Subject: **Additional Information Response for the 401 Certification and Buffer Authorization** for the replacement of Bridge No. 14 located on NC 87 over Cane Creek, Alamance County
DWR# 20250885

Reference: On hold letter dated August 1, 2025 (DWR# 20250885)

Additional Information Response Package for BR-0060 (DWR #20250885)

LOCATION: REPLACE BRIDGE 000014 ON NC 87 OVER CANE CREEK

PERMIT DRAWING
SHEET 8 OF 12

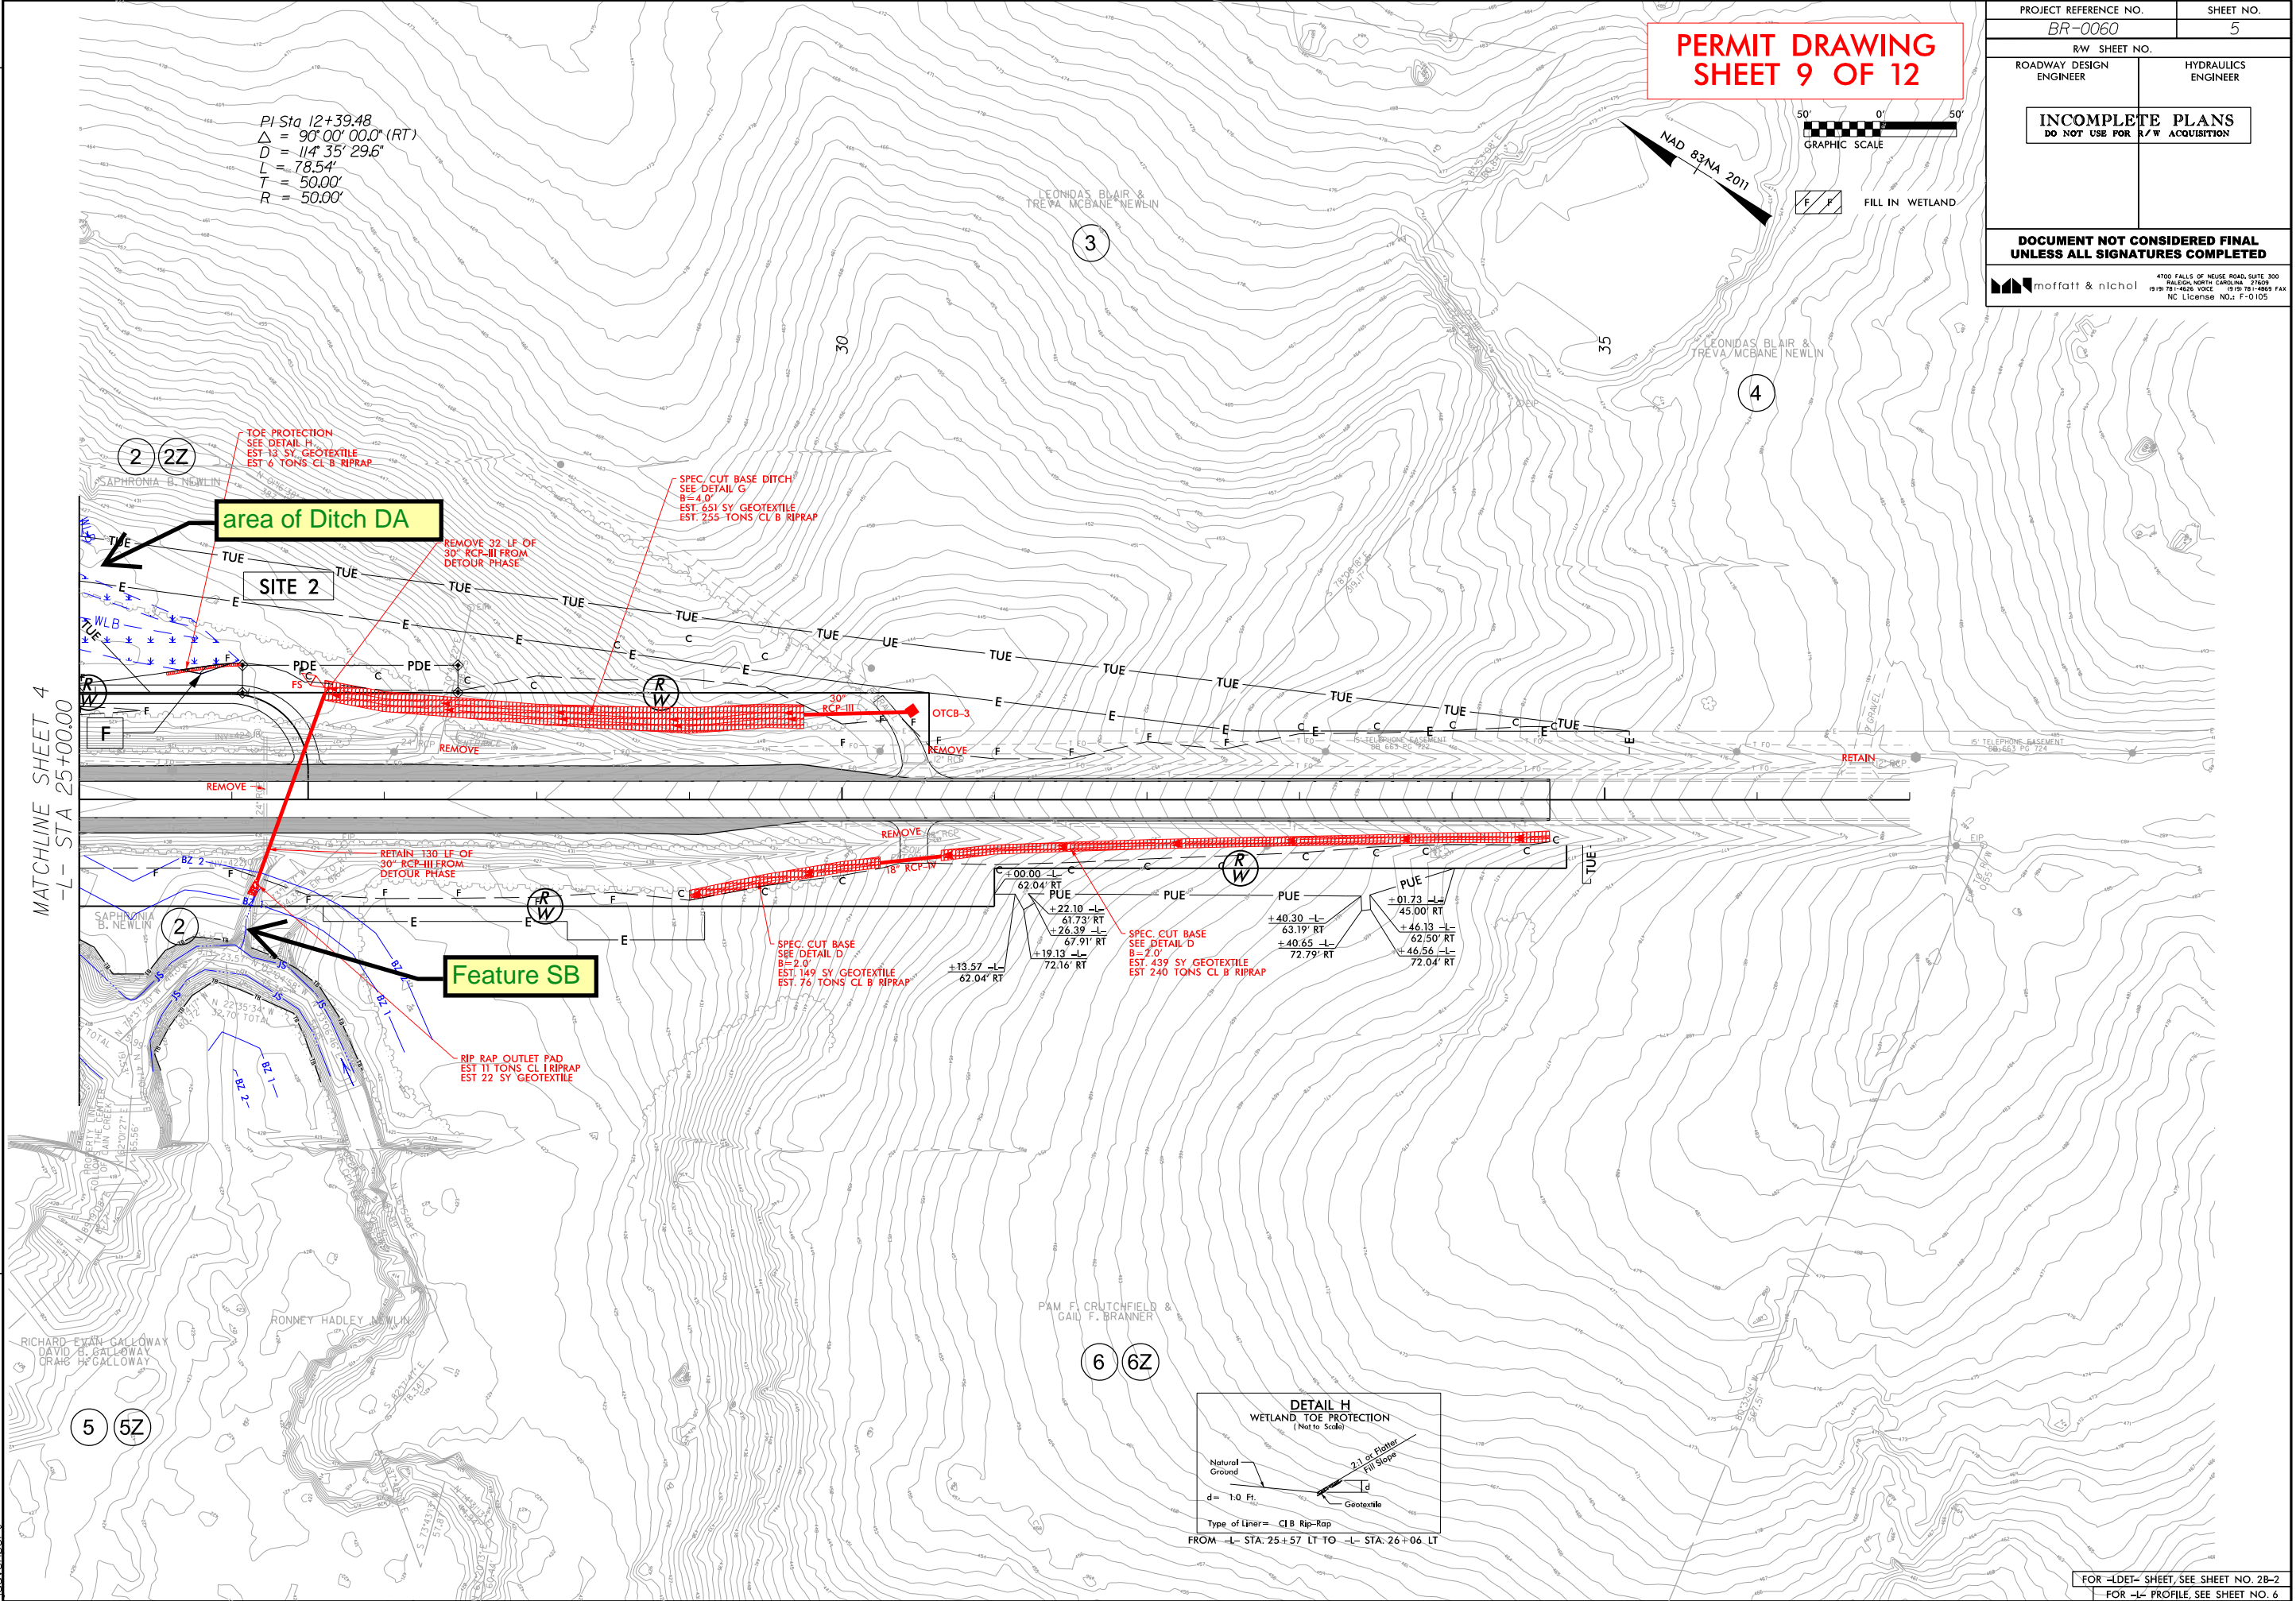
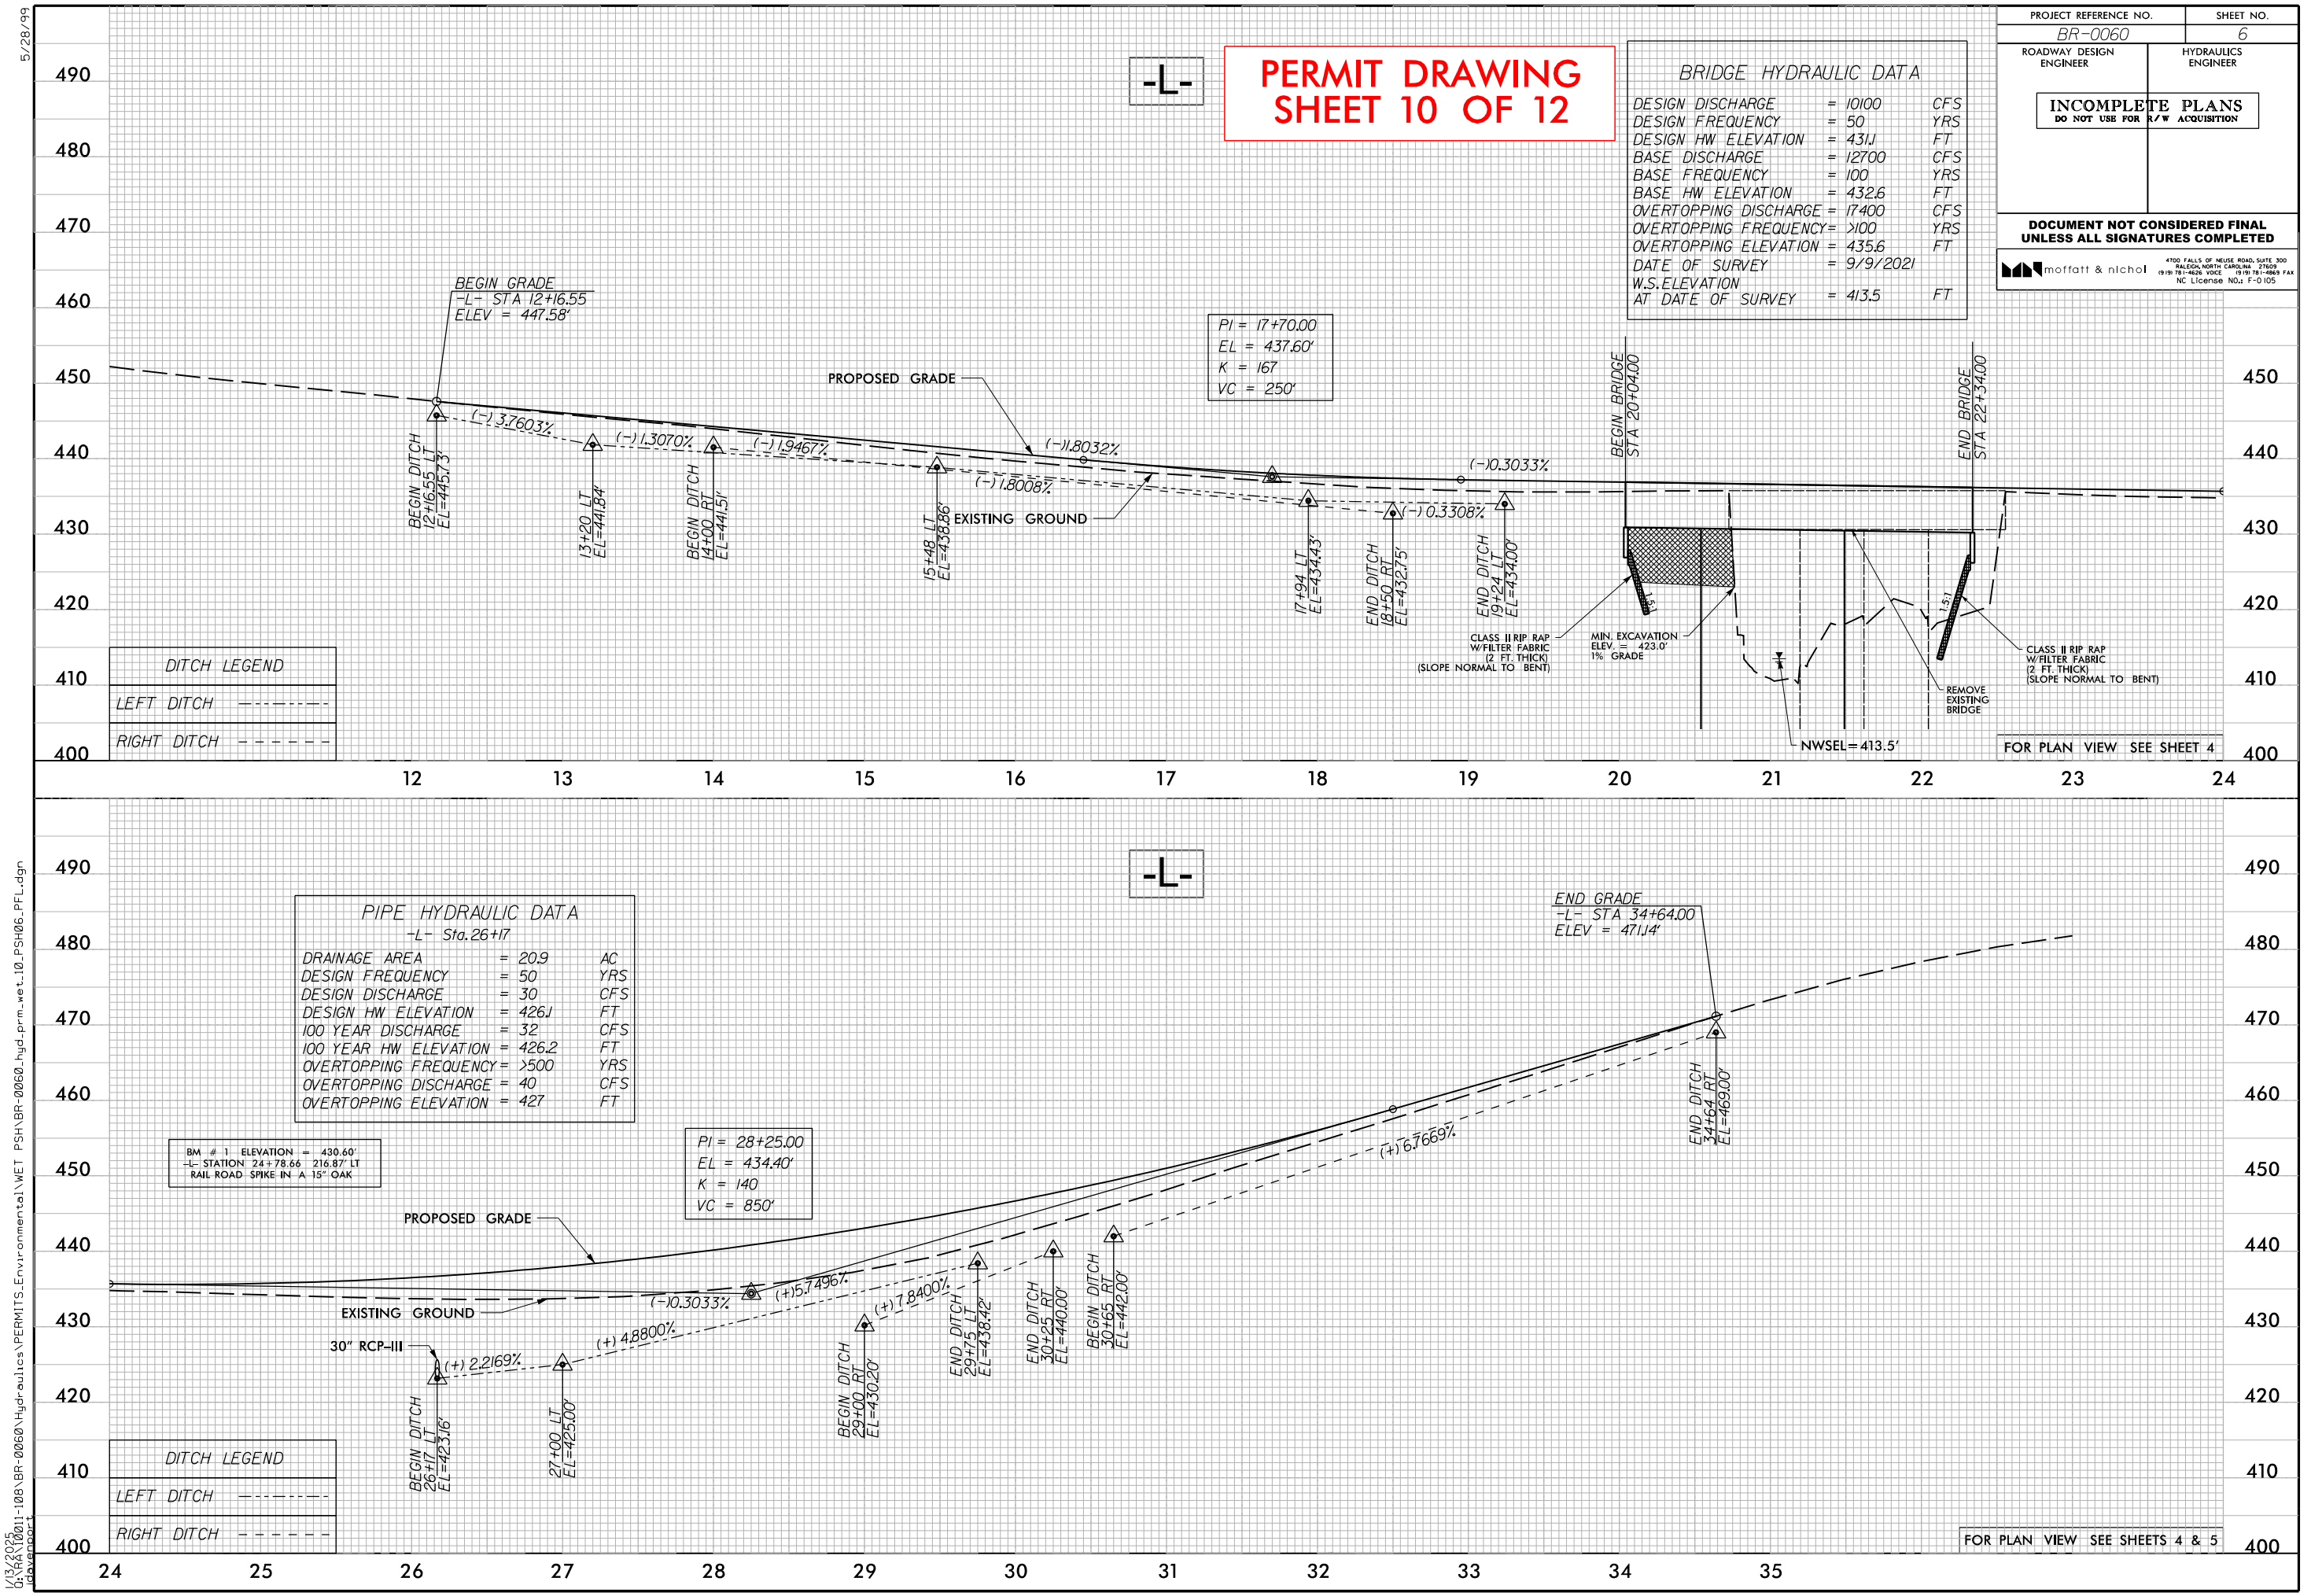
Confirm Sheet 5 of the Permit drawings. At the end of the Project and east of NC 87, there is an off-site pond which appears to drain into the Project area. Please provide supporting information and data forms collected in this area.

Please label stream SB and Stream SC throughout the permit and buffer drawings.

Stream SC does not appear to be depicted on the permit drawings.

During the site visit by our consultants, there was no drainage from the off-site pond to the study area identified. Therefore, no forms were completed. Also, Location & Survey did not pick up a drainage feature from the off-site pond to the study area. It appears that any drainage from the off-site pond flows to the roadside ditch (see attached photo of the drainage area. The [link below](#) directs to this particular area, between the off-site pond and drainage roadside ditch on Google Maps).

The non-JS blue line feature (SB) has been labeled on the permit and buffer drawings.

As described in the Response to DWR Comment 2, Stream SC has been updated to/labelled as Ditch DA (in attachment) and a label has been included on permit and buffer drawings.

Feature SC referred to in this DWR Comment, and labeled as such on the Jurisdictional Determination Map in the CE Document, was determined to be ephemeral (Stream ID score of 10.5). It is depicted on the Figure (*Potential Jurisdictional Features Map*) included in the attachment as **Ditch DA** (SC = Ditch DA). As NCDOT's Location & Survey group did not pick this up as a drainage feature, it was not depicted on the permit and buffer drawings. A label has been placed on the permit and buffer drawings, included as an attachment, in the vicinity of the ditch (DA).
